CASQA Comments on Revised Draft General Permit for Small MS4s

Board Workshop
January 8, 2013

Size Comparison E.12 and Att. J

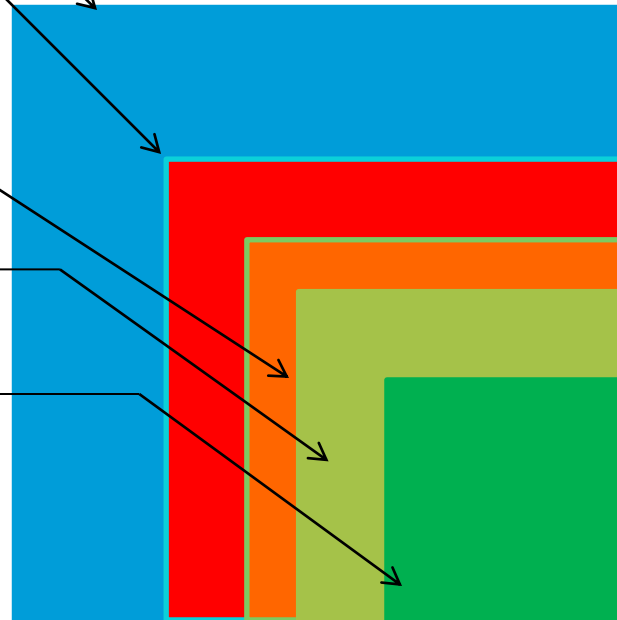
- Project thresholds
 - E12: two tiers (small and large projects)
 - Central Coast Att. J: four tiers
- Sizing criteria
 - E12: 85th percentile or 4% of impervious area
 - Central Coast Att. J: 85th, 95th, 85th/95th x 1.963, unless infeasible, then 10% of EISA, add peak flow control...
- BMP design specifications
 - 18" (E12) vs. 24" (Att. J) planting soil depth
 - Infiltration/harvesting/ET vs. infiltration only

Bioretention simple sizing method assumes design volume for Santa Barbara rain gage is provided in 6 in. ponded water and 3 ft. media void space

Flow Duration Curve Comparison

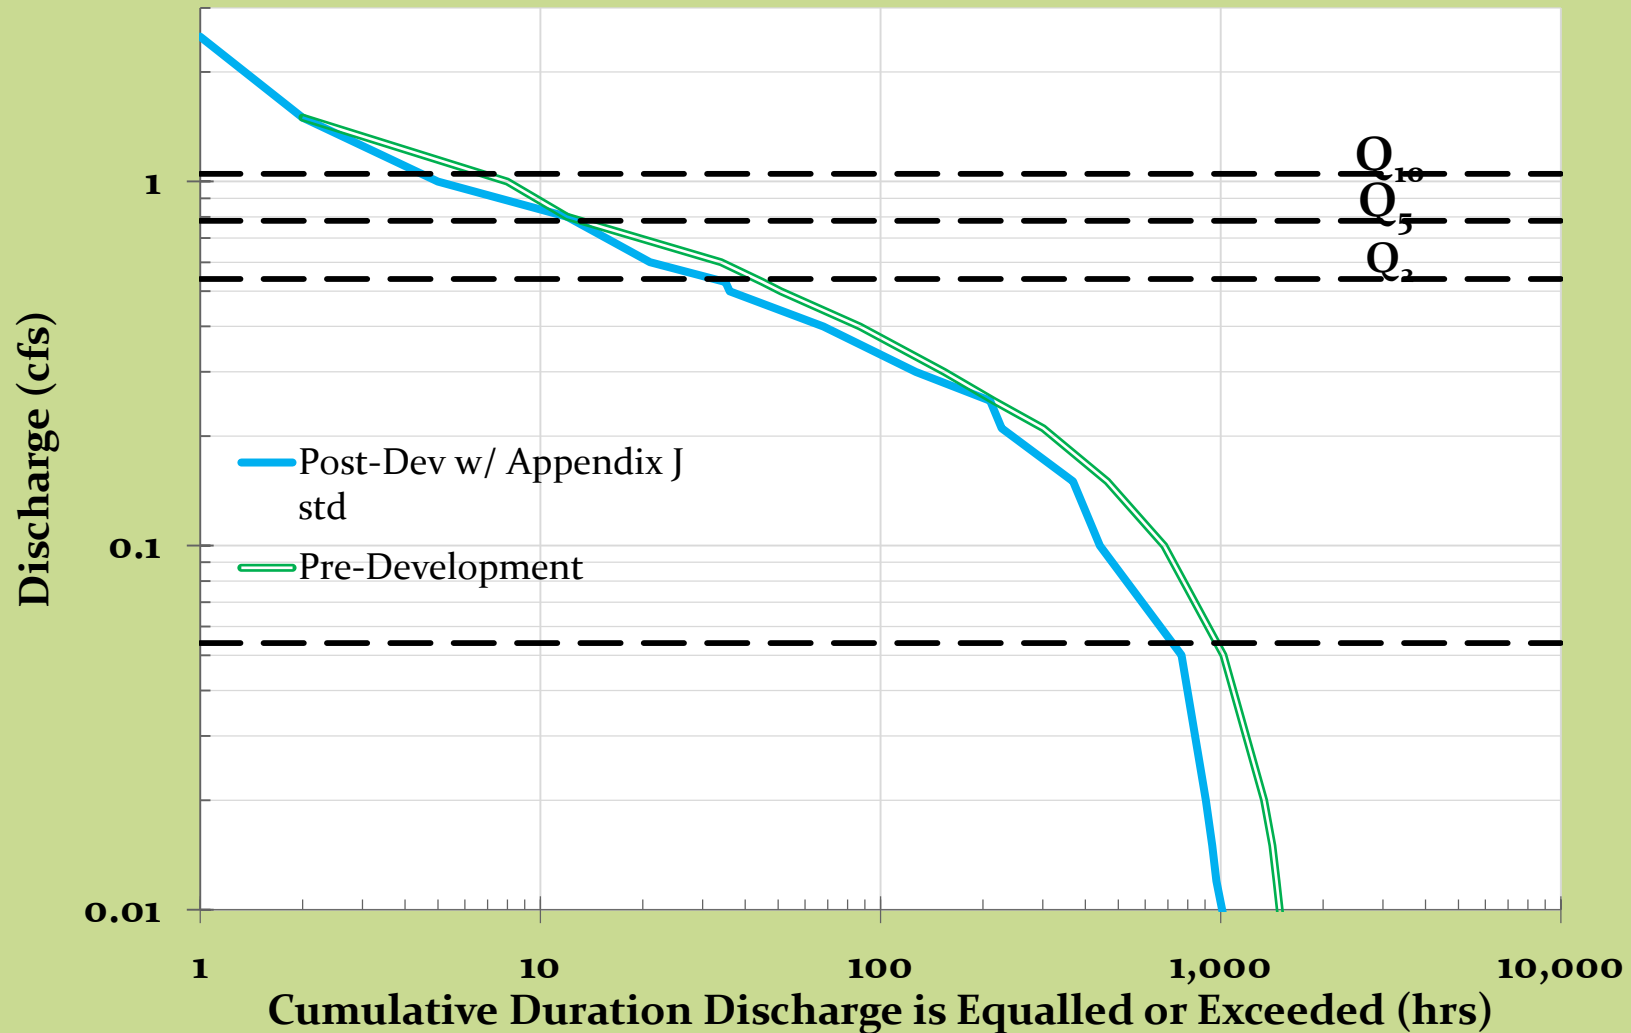
- Goal is to “maintain watershed processes” such as overland flow, infiltration, base flow, and sediment transport
- Members of CASQA Phase II subcommittee ran a continuous simulation model to examine effects of different criteria
 - No performance gain in 24 in. vs. 18 in. media depth
 - More runoff is captured and retained with App. J standard (maximized at 10% of site) than in undeveloped condition

Summary: Bioretention sized per App. J results in oversized BMPs

Santa Barbara rain gage, K_{sat} undeveloped = 0.05 in/hr, K_{sat} under bioretention = 0.2 in/hr, bioretention w/ 6 in ponding, 24 in media, 12 in gravel covering 10% of one acre impervious area.

- E.12 was developed over a 2 year period with general agreement amongst stakeholders, is easy to interpret and implement
- Delete all references to the Central Coast Post-Construction Requirements and Attachment J
- Allow one permit cycle to implement E.12 as proposed
- During this time, thoughtfully work out how watershed management zones will be incorporated into post-construction standards in next permit term in a technically-correct and implementable manner
